STATE OF DELAWARE
EXECUTIVE DEPARTMENT
OFFICE OF MANAGEMENT AND BUDGET
STATE PLANNING COORDINATION

September 13, 2005

RE: PLUS review – PLUS 2005-08-03; Lankford Jones

RE: Agreement No. 1294
Traffic Impact Study Review Services
**Task No. 15 – Route 54 Synchro Analysis for the Route 54 (Jones/Lankford)
Property**

Figure 2. Time-Space Diagram for Unsignalized Intersection Scenario.

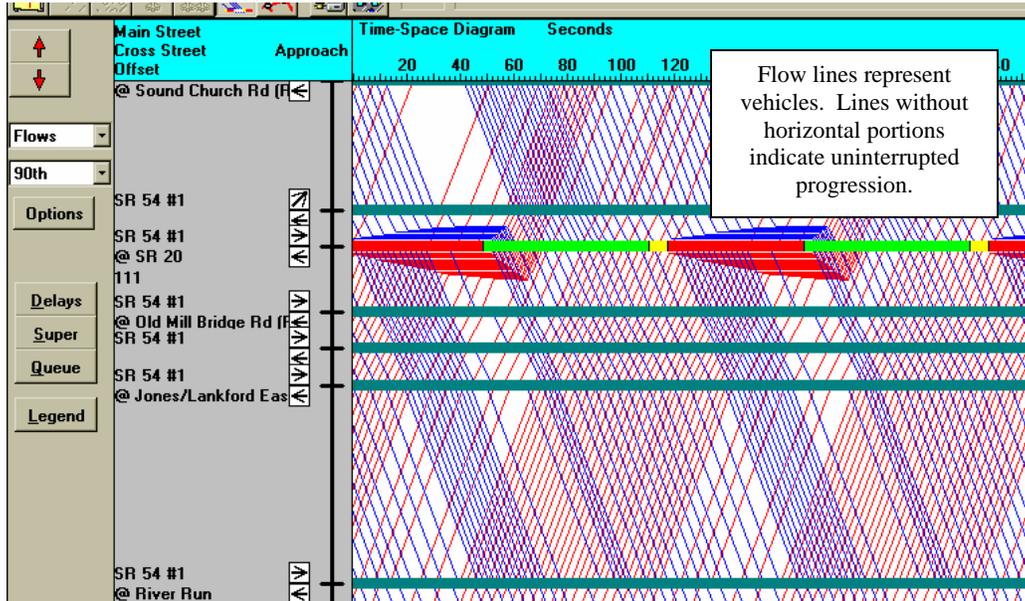
Using the same methodology used in the November 2002 Traffic Signal Location Study, as well as considering the time-space diagrams which take into account the flow along the corridor, McCormick Taylor determined that a signal installed at the Jones/Lankford entrance on Route 54

will inhibit progression on Route 54, and therefore a signal is not recommended. The proposed development is not consistent with the Sussex County Comprehensive Plan. The proposed development has 120 condominiums being built on 17.94 acres of land, over 6 dwelling units per acre of land. This parcel of land is designated as “low to medium density” in the Sussex County Comprehensive Plan, which is noted to include densities of 1 to 3 dwelling units per acre.

The following figures show the time-space diagrams for the signalized and unsignalized scenario. It is important to note that flow lines with a horizontal section indicate that vehicles are stopping at that intersection and therefore inhibiting progression. In the unsignalized intersection scenario you see vehicles being stopped at the intersection of Route 54 with Route 20 and then progressing through the surrounding intersections. Those in the signalized scenario stop at both the signal at Route 54 and Route 20 and the signal at Route 54 and the site entrance.
